SUGARBUSH RESIDENTIAL DEVELOPMENT PROJECT

CONCEPTUAL FIRE PROTECTION PLAN (FPP)

FIRE PROTECTION PLAN INFORMATION FOR THE READER

**Fire Protection Plan
for
Sugarbush; Tract 5295 RPL-7
Vista, California**

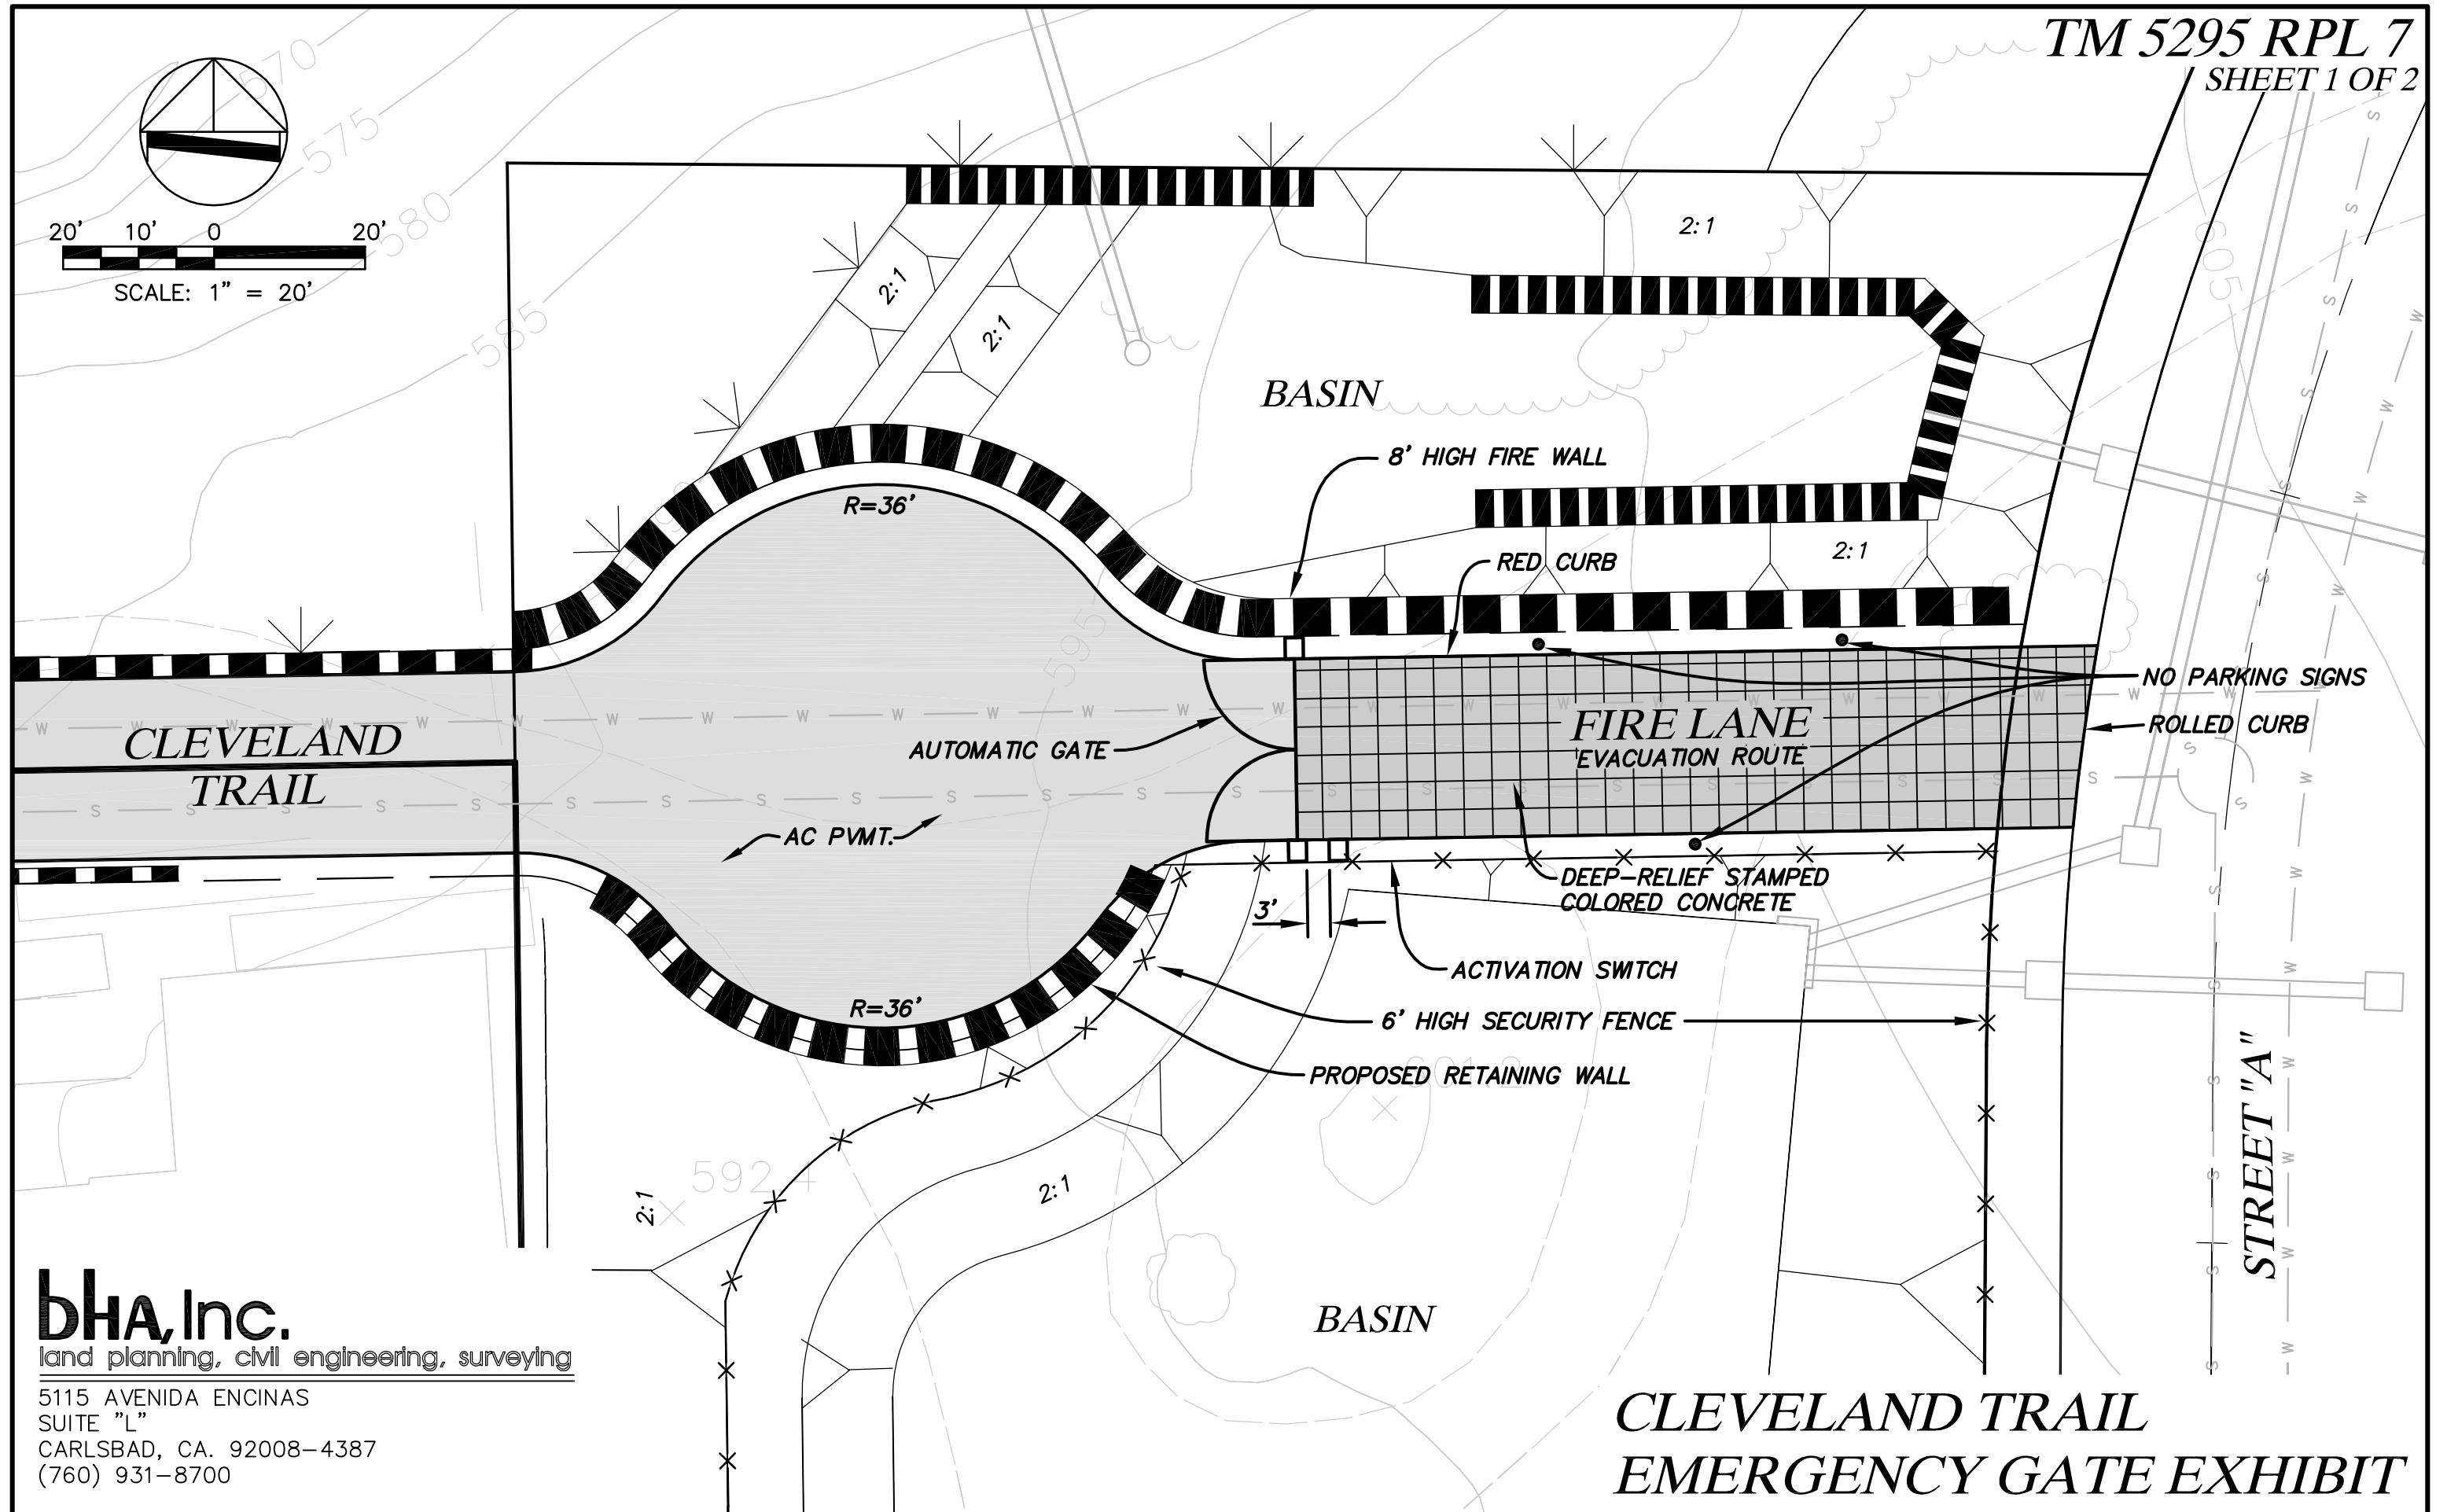
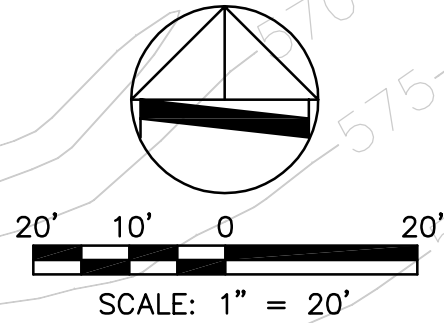
The speed of the fire response vehicles was altered from 45 to 35 miles per hour. Emergency response times would remain under the County of San Diego's threshold of five minutes utilizing Cleveland Trail. In addition, the document has been modified to further discuss the emergency access/egress gate requirements to Cleveland Trail. Finally, the Plan has been revised to include two exhibits depicting emergency access/egress specifics pertaining to Lot F, which are attached to this Information for the Reader.

GATE DETAIL
NOT TO SCALE

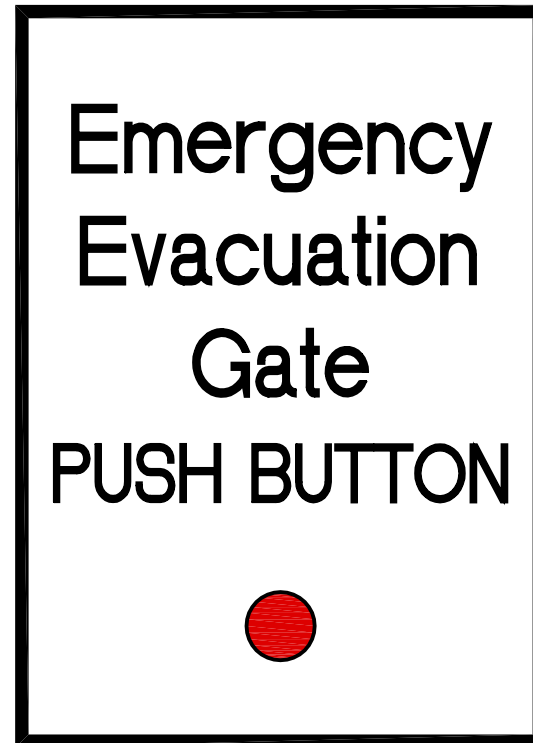
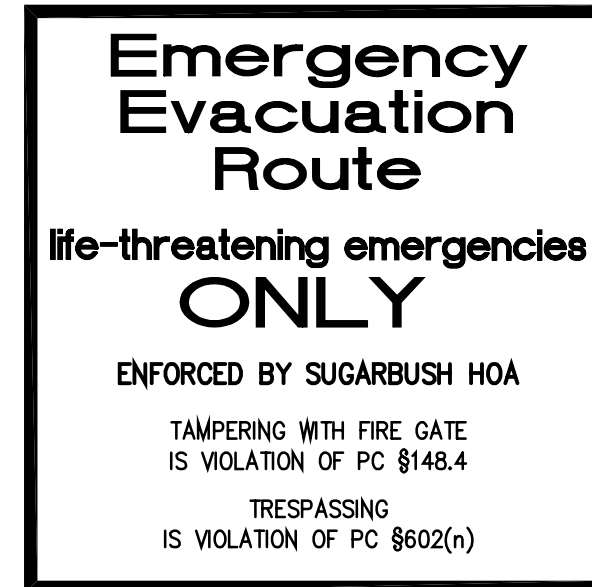
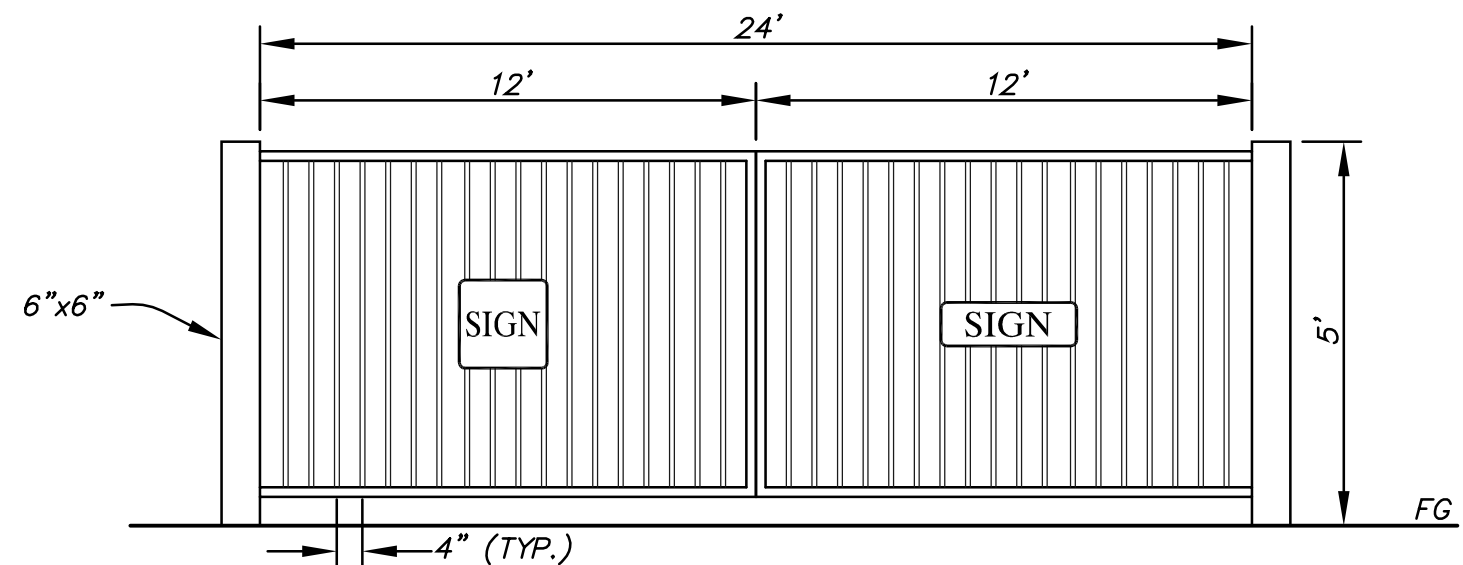
POST EVERY 40' ALONG FIRE LANE.
STANDARD SIGNS REFERENCING CVC SECTION
ALSO POST ON CUL-DE-SAC AND WEST
FACING GATE.

POST AT ACTIVATION
SWITCH

TO BE MOUNTED ON EAST SIDE OF GATES OR
GATE ACCESS ONLY, NOT ON WEST SIDE

TO BE MOUNTED ON WEST FACING SIDE OF GATES ONLY, NOT ON PROJECT SIDE
